Northern/Orangewood  
Storm Drain Project  
Contract FCD 94-12, Phase II  
*Glendale Avenue Storm Drain*  
*Sub-Phase "B"*

*Project Correspondence*

**Response to Comments  
for  
Storm Drain-Irrigation Line Conflict Structure**

**Response to Review Comments  
for  
East Basin Design Concept Analysis**

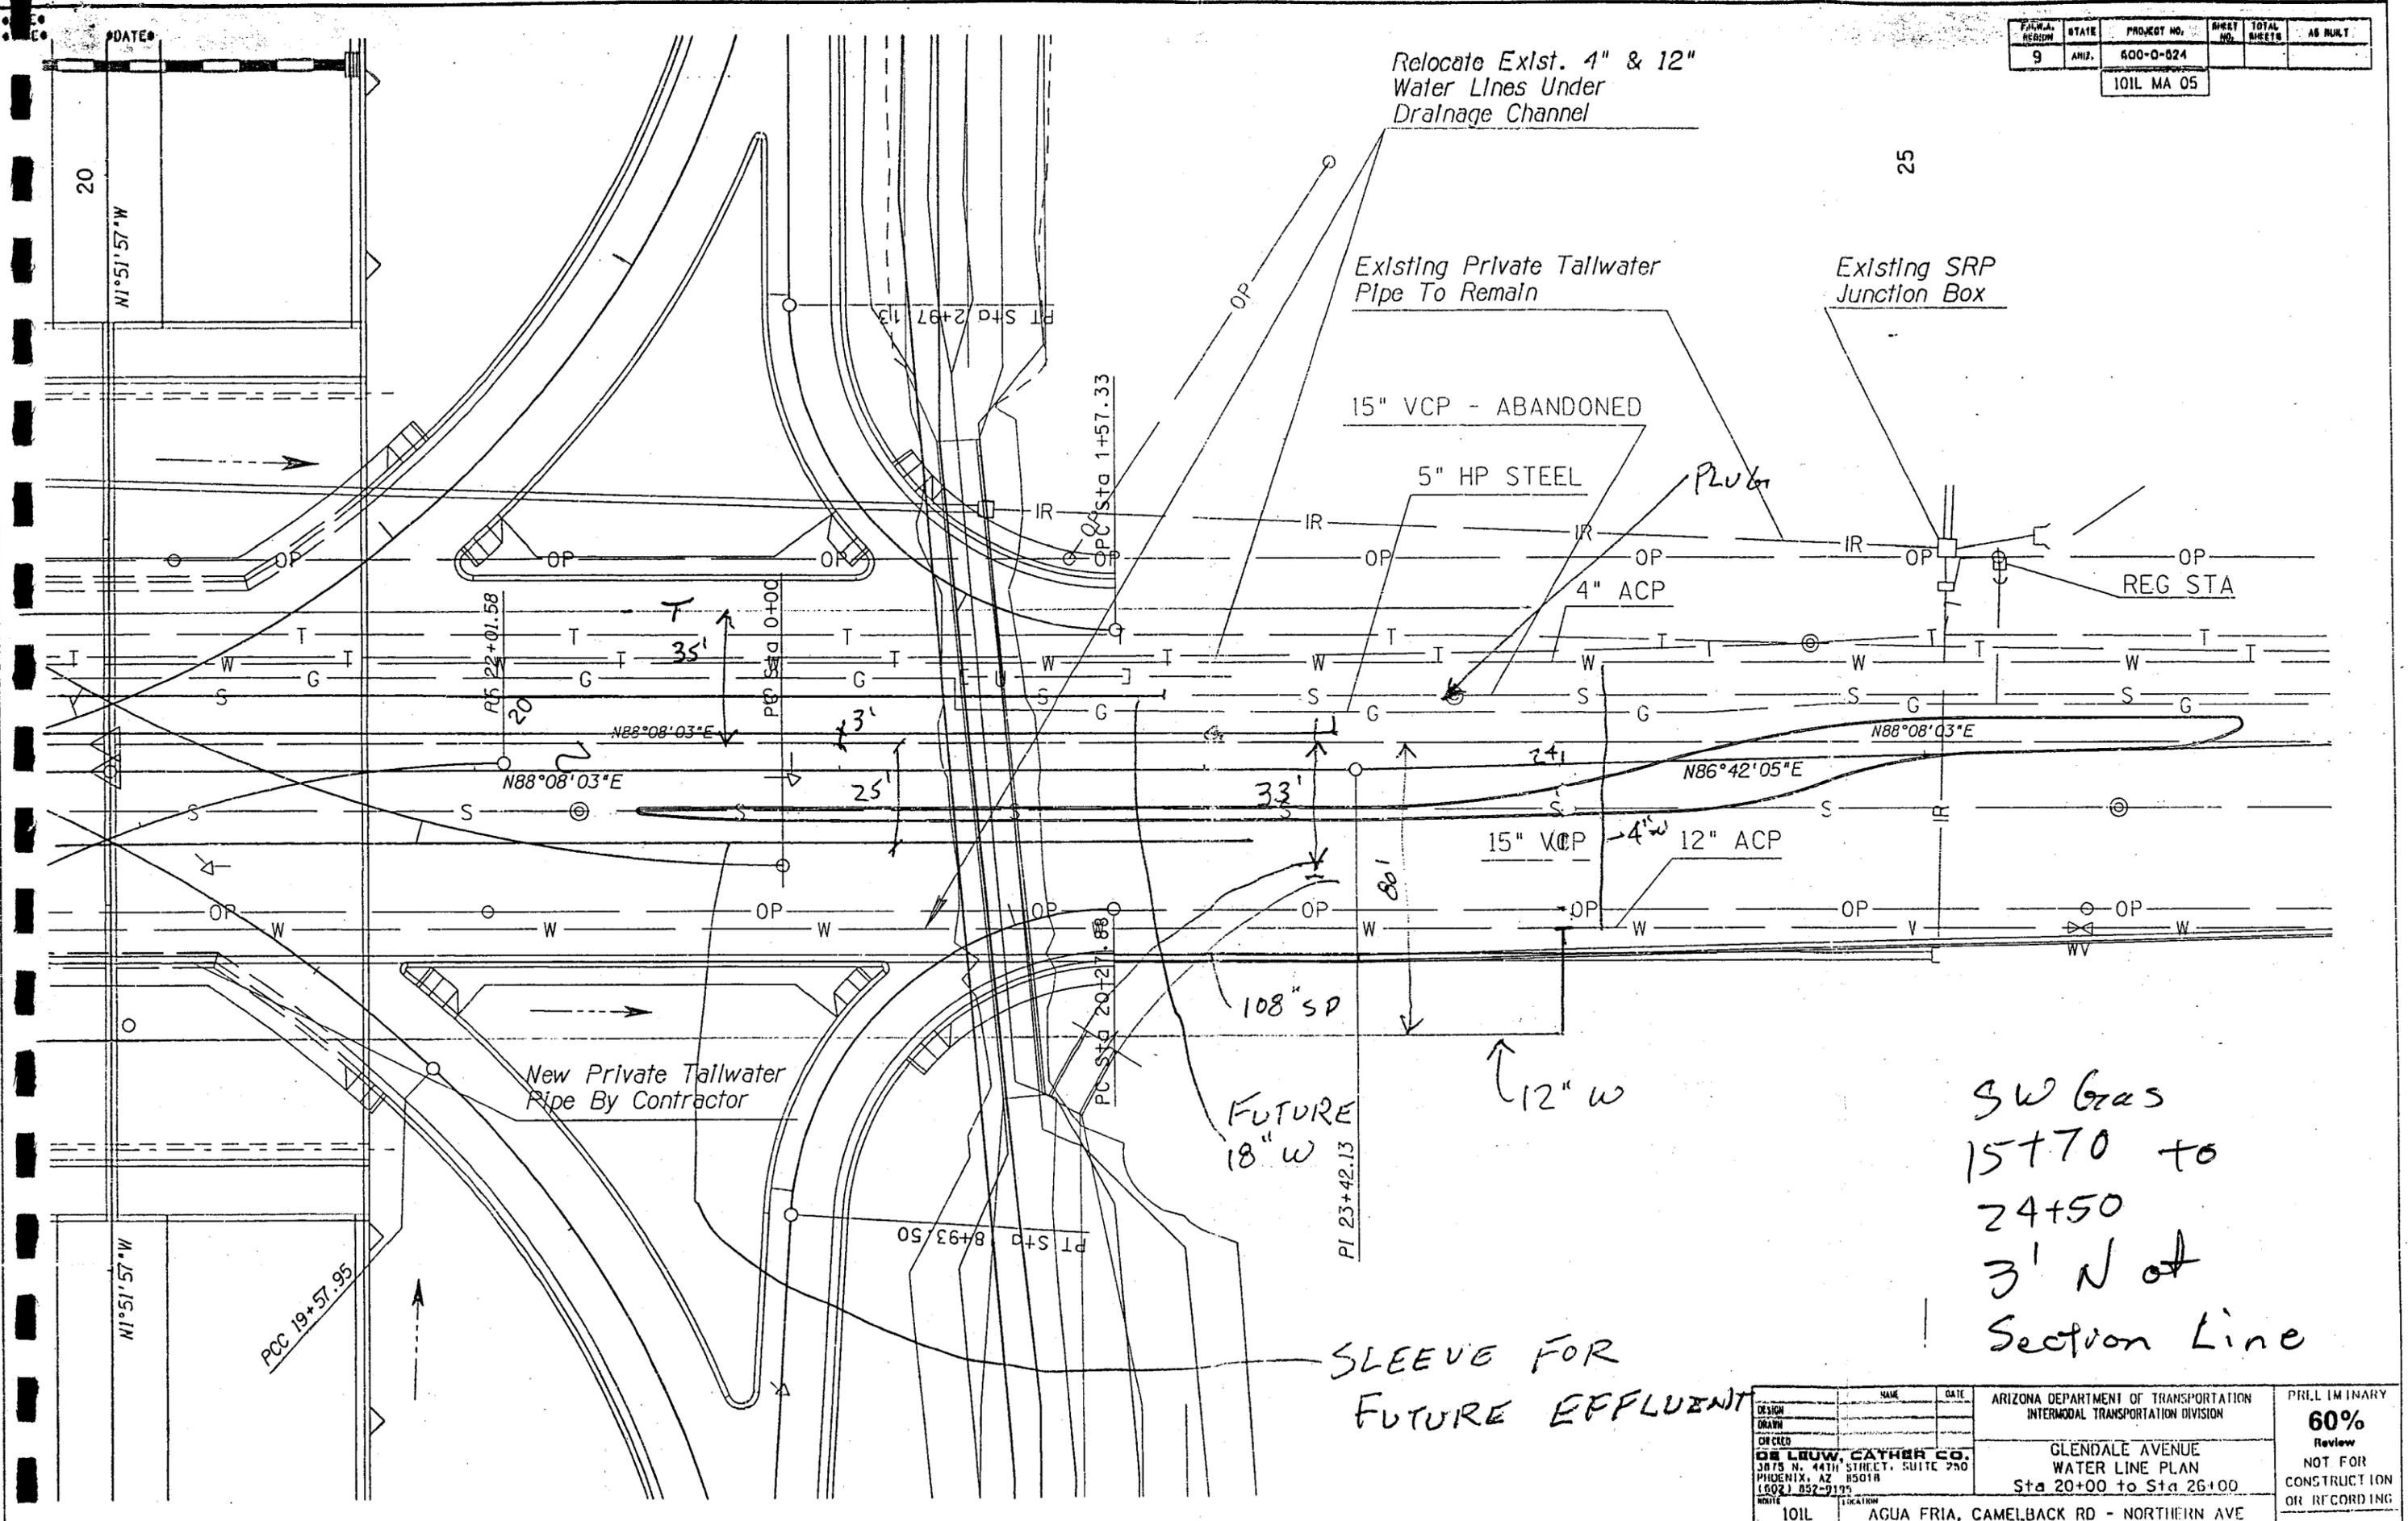
THE ATTACHED SKETCHES SHOW EXISTING AND PROPOSED UTILITY LOCATIONS FOR GLENDALE AVENUE AT THE AGUA FRIA FREEWAY.

THE 24" FUTURE EFFLUENT LINE IS PROPOSED TO BE LOCATED 25 FEET SOUTH OF THE SECTION LINE. THE SLEEVE WILL EXTEND TO OUTSIDE OF THE LIMITS OF PCCP, AND ANOTHER 50 TO 60 FEET OF SPACE IS DESIRED FOR A JACKING PIT.

IF THERE ARE CONFLICTS WITH OTHER FACILITIES THAT PREVENT MOVING THE STORM DRAIN TO 37', IT COULD MOVE BACK TO 33' AFTER IT IS EAST OF ABOUT STATION 24+50.

Storm Drain/Irrigation Line  
Conflict Structure

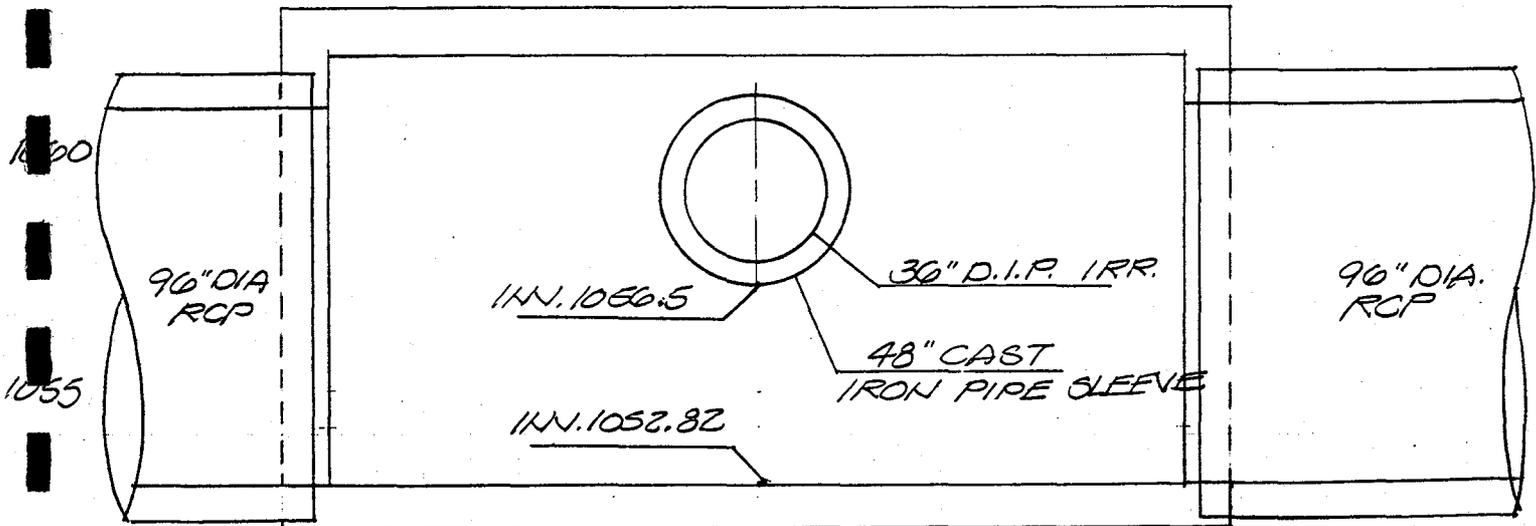
Overall, the suggested design is unfavorable, and alternatives such as siphons or transitions with box culverts under the irrigation lines are considered preferable.

If the current design is to be selected, the following should be included:

A) Structure dimensions and shape should be such that there will be a 4:1 or longer expansion possible for flows which will enter the structure, before reaching the upstream edge of the Irrigation line sleeve. In addition, the dimensions and shape of the structure downstream of the irrigation line should be such that a 2:1 or longer contraction is possible for flows between the downstream edge of the irrigation line sleeve and the pipe entrance. The clear area under the irrigation line should either be the area of full flow for an equivalent diameter pipe, or the area of the currently proposed pipe, whichever is greater.

The use of siphons has been discussed and eliminated as an acceptable alternative. SRP would only consider a siphon if the city of Glendale (COG) were to agree to a maintenance agreement. The COG does not wish to engage in such an agreement. Both the COG and the FCDMC were opposed to siphoning the storm drain.

Box structures were looked at as an alternative to the proposed structure. However, due to the limited vertical clearance at all three crossing locations a very shallow, wide and long structure would be required. The following structure size would be required at the three crossing locations:

With the use of transitions from comment # 2A and an equivalent flow area between the bottom of the irrigation pipe sleeve and the invert of the box, we would recommend using a loss coefficient of 0.4. This will create a loss through the structures of approximately 0.5'. A coefficient of 0.8 in our opinion is very high. It would cause a loss through the structures of approximately 1' which is comparable to a 90° bend which we feel is excessive.

99th Ave & Glendale Ave  
RID & Storm Drain Vertical  
Conflict

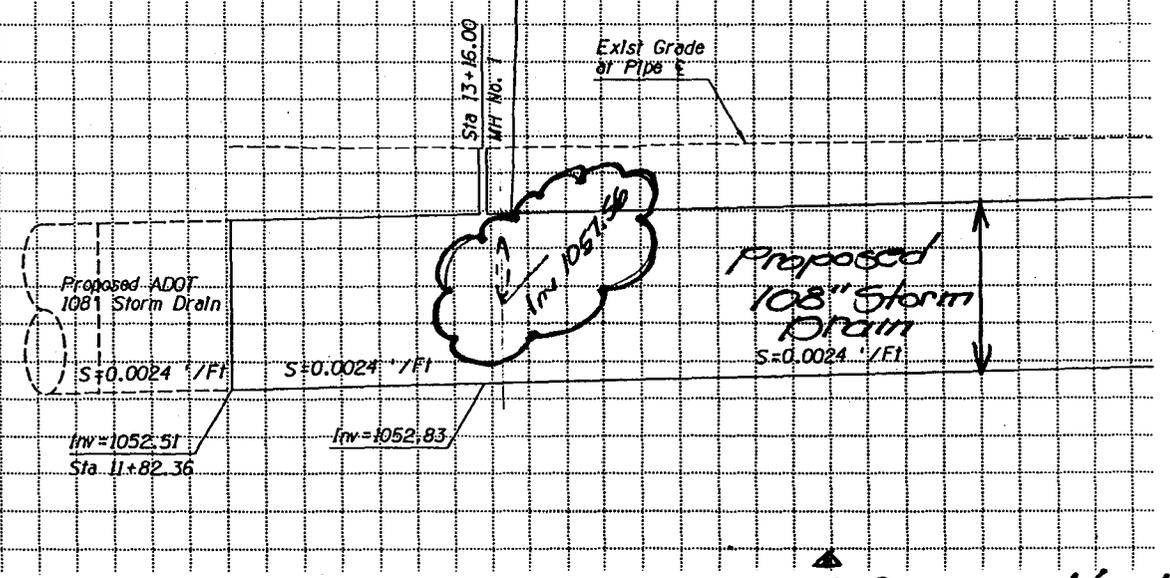
.....  
I have attached a sketch of the proposed Glendale Ave Storm Drain at 97<sup>th</sup> Ave.  
.....  
As shown, there is a conflict with your 36" Irrigation line at this location. We would like  
.....  
to dip (siphon) the irrigation under the proposed storm drain to resolve the conflict.
